Attachment B1

Selected Drawings

PROJECT
2235 BILLYARD 21C
DRAWN SENIOR QA APP'D
MP CM WS

DWG TITLE
LEGEND, DRAWING LIST, SITE MAP
DWG NO REV
DA000 J

1 O B05-B04 + B GF

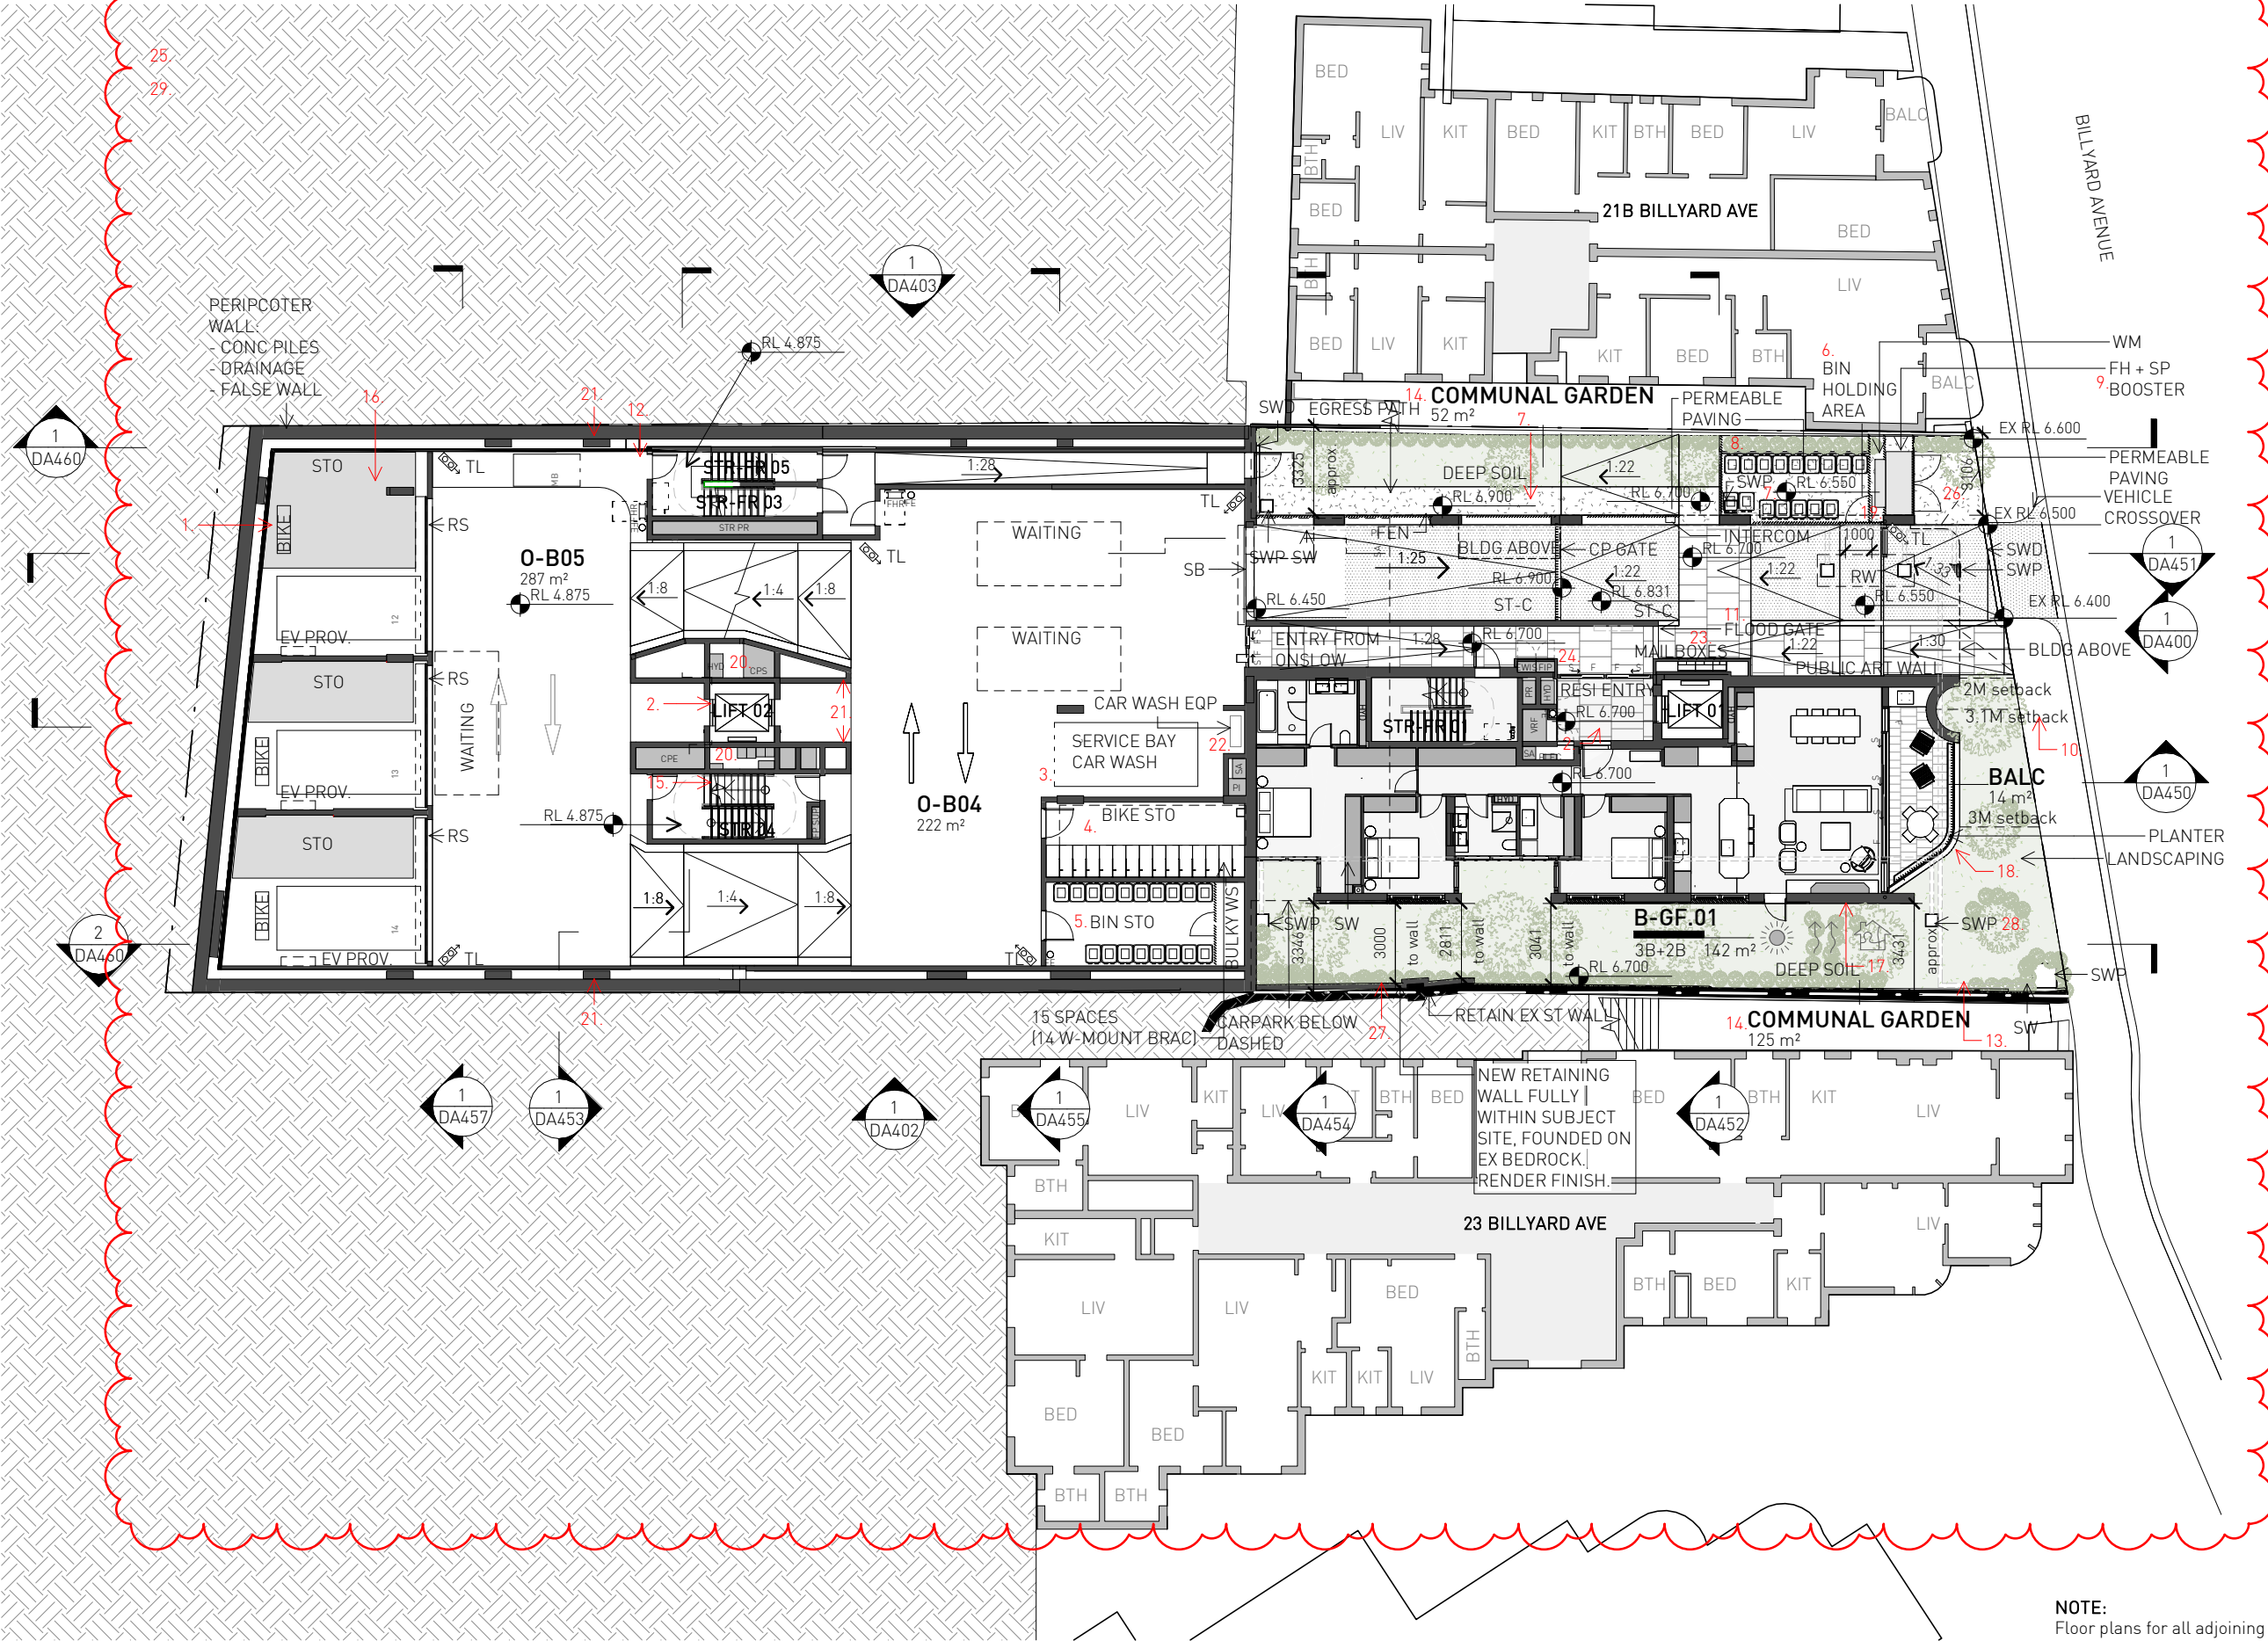
- EXISTING NEIGHBOURING WALL RETAINED
- O-B05 parking layout revised. Roller shutter garage enclosure shown. Bike spaces allocated in garages.
 - Waste Chute removed in both buildings.

- Service bay added to O-B04 level.
 - Bike Storage added to O-B04 level.
 - Permanent bin store relocated to O-B04 level. Cage around bulky waste proposed.

- Temporary bin holding area located adjacent to west setback.
 - Permeable stone introduced in deep soil areas.
 - Deep soil areas maximized.
 - Sprinkler & Fire Booster updated to I-pattern.

- Billyard front setback increased by 1m.
 - Flood gate proposed.
 - Motorbike space added.
 - Gas meter removed. Fully electric building proposed.
 - Communal gardens introduced on Billyard GF.

- Carpark EXH fans relocated from roof.
 - Storage added to garages.
 - Billyard building footprint reduced by 400mm.
 - Balconies splayed.
 - Entry to bin holding area relocated to the ramp landing.

- DA ISSUE 07
- Services areas adjusted.
 - Structural elements adjusted.
 - Car wash bay integrated to service bay area.
 - Mailboxes relocated.
 - FIP shown.
 - Structural elements, service risers, windows position, apartment layouts updated.

- DA ISSUE 08:
- Door swings added to fire booster enclosure.
 - New retaining wall added and deep soil adjusted.
 - Lemon myrtle moved away from pipe.

- DA ISSUE 09
- Detailing of services, structural elements & perimeter walls shown.

1 O B03-B02 + B L01

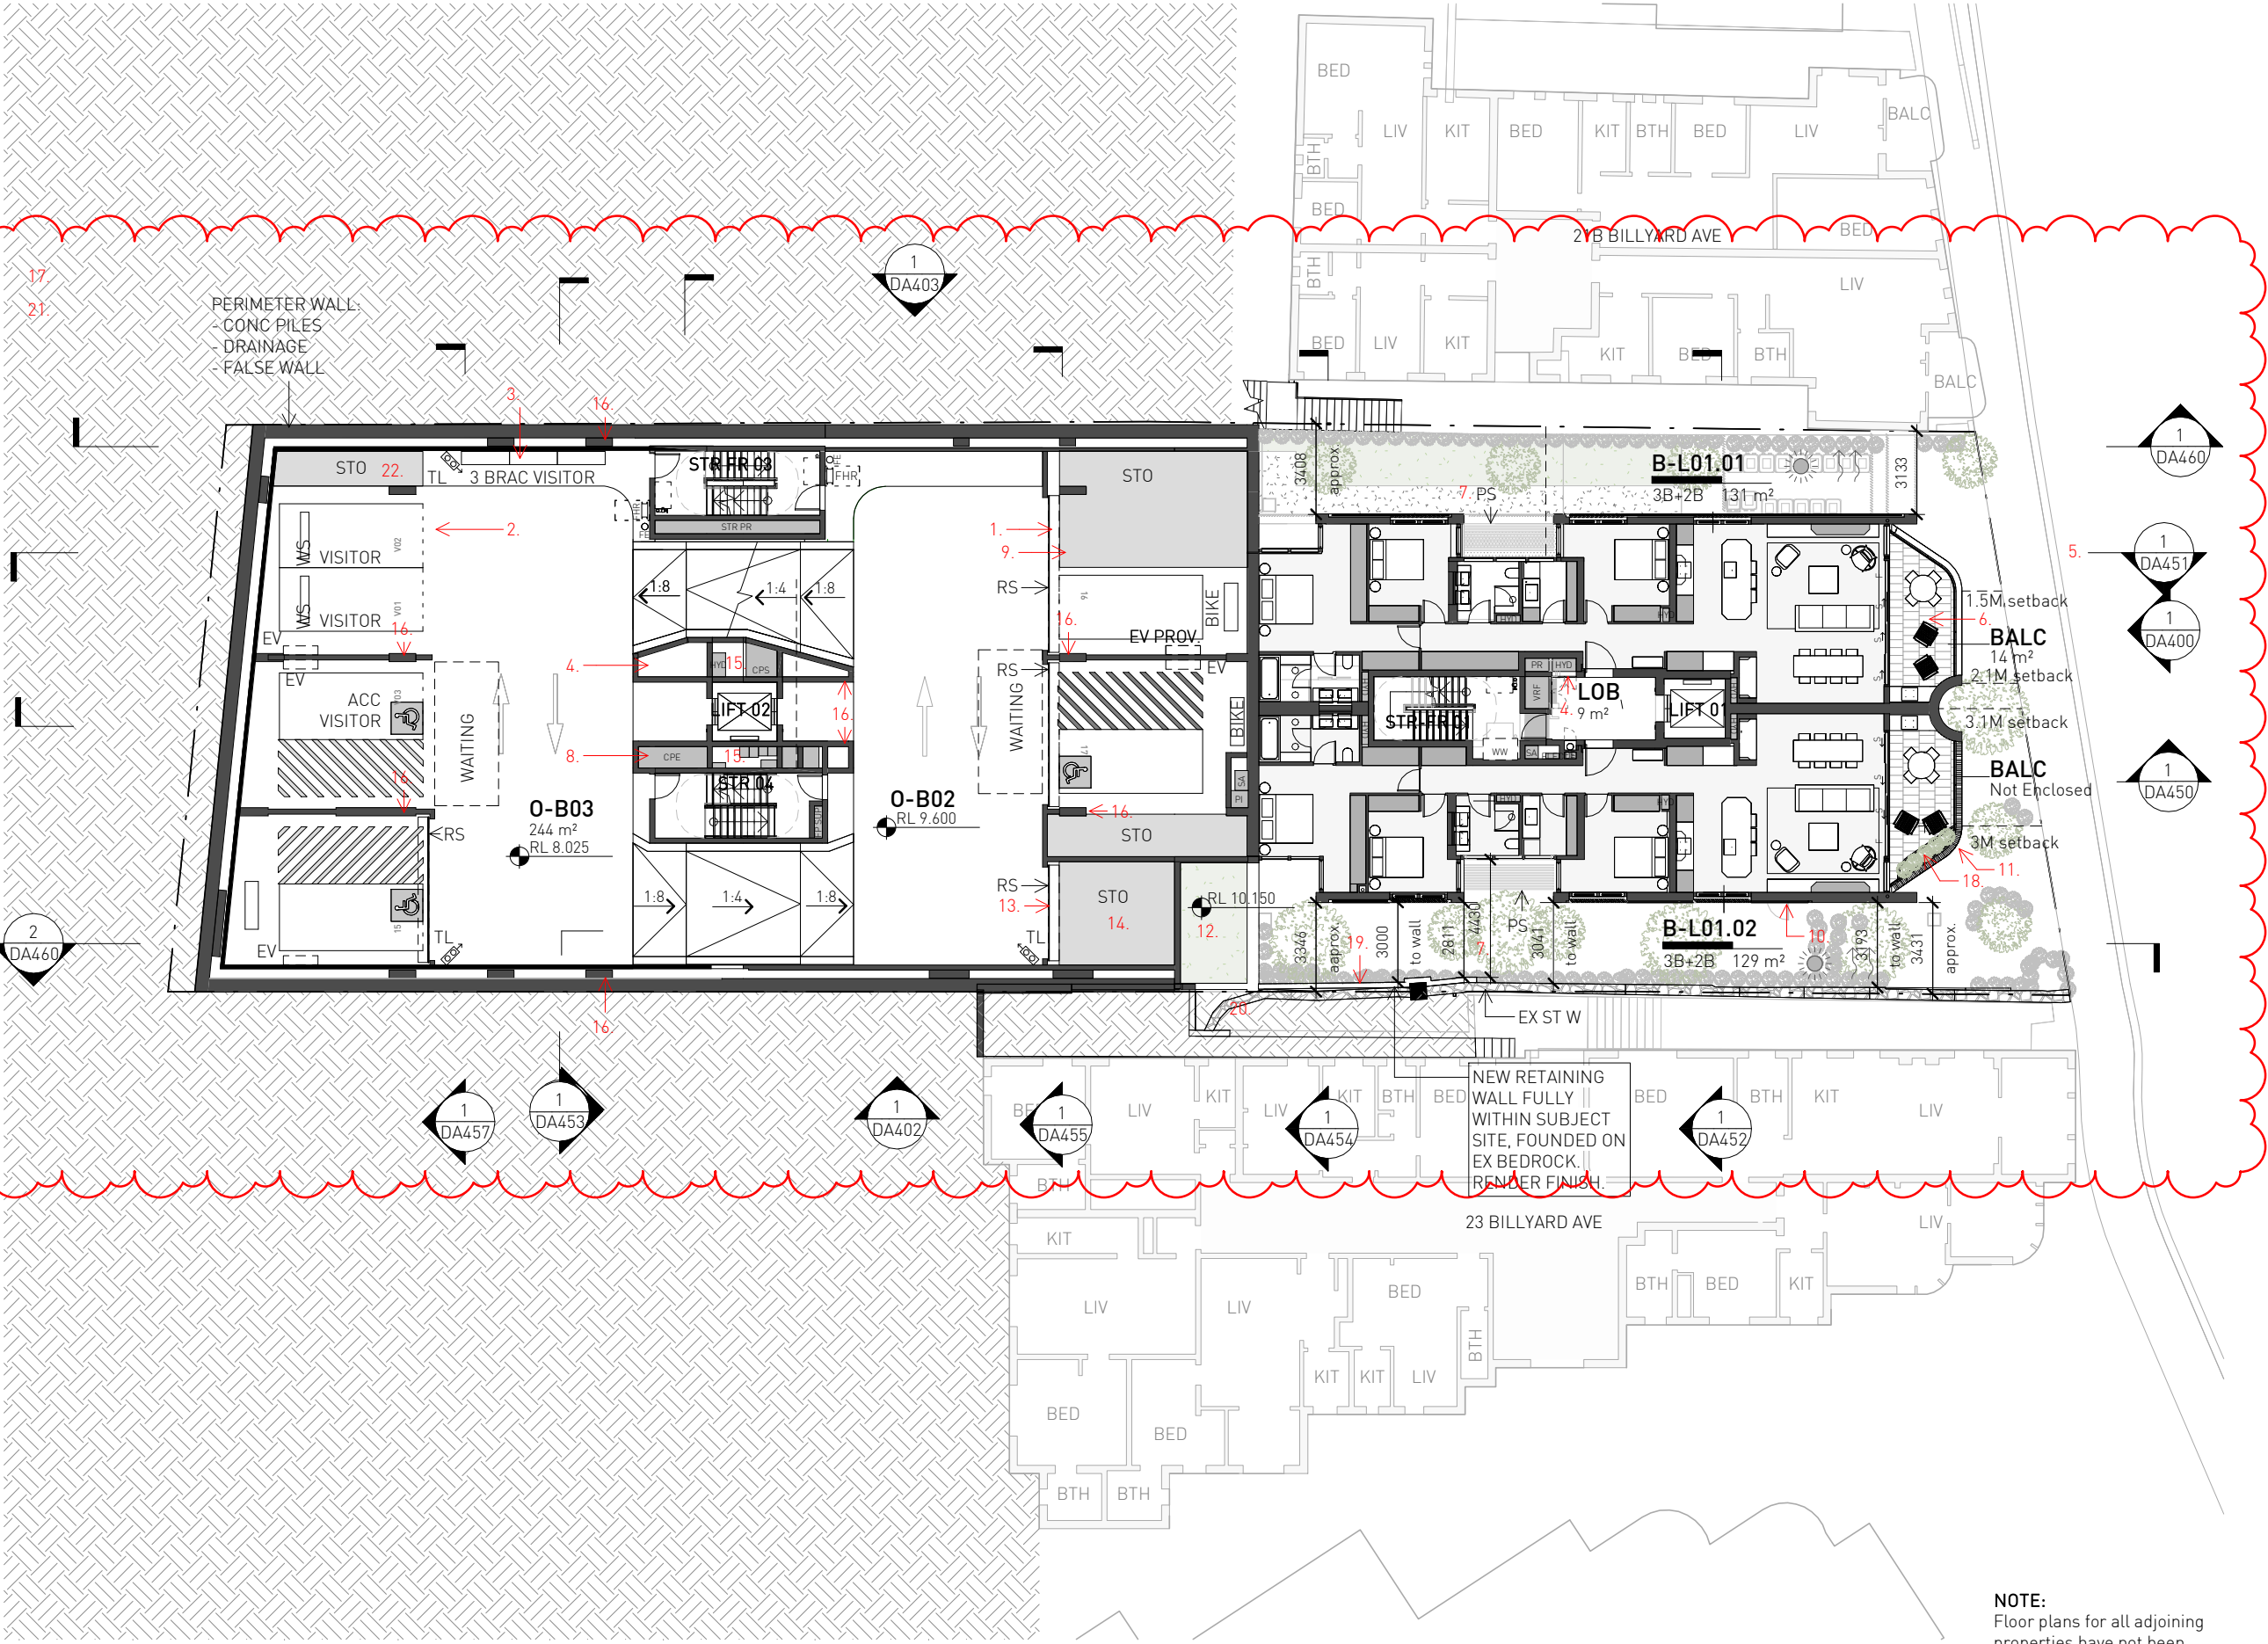
- EXISTING NEIGHBOURING WALL RETAINED
- O-B02 & O-B03 parking layout revised - Spaces 15 & 17 allocated for adaptable units. Roller Shutter garage enclosure shown. Bike spaces allocated in garages.
 - O-B03 parking layout revised. All visitor spaces relocated to O-B03 level.
 - Visitor Bicycle spaces added on O-B03.
 - Waste Chute removed in both buildings. Risers revised.
 - Billyard front setback increased by 1m.
 - Billyard balconies depth decreased to 2.4m as a minimum in order to maintain min. depth of living areas after increasing street setback.
 - Horizontal privacy screen added to building indents.
 - Carpark EXH fans relocated from roof.
 - Storage added to garages.
 - Billyard building footprint reduced by 400mm.
 - Balconies splayed.

- DA ISSUE 07:
- Planter area dropped.
 - Garage no. 18 adjacent to the eastern planter removed. Spaces on level above renumbered accordingly.
 - STO added.
 - Services areas adjusted.
 - Structural elements adjusted.
 - Structural elements, service risers, windows position, apartment layouts updated.

- DA ISSUE 08:
- Planter added to eastern balcony for visual privacy.
 - New retaining wall added and deep soil adjusted.
 - Graphic representation of neighbouring properties shown.

- DA ISSUE 09:
- Detailing of services, structural elements & perimeter walls shown, also including:
 - STO added.
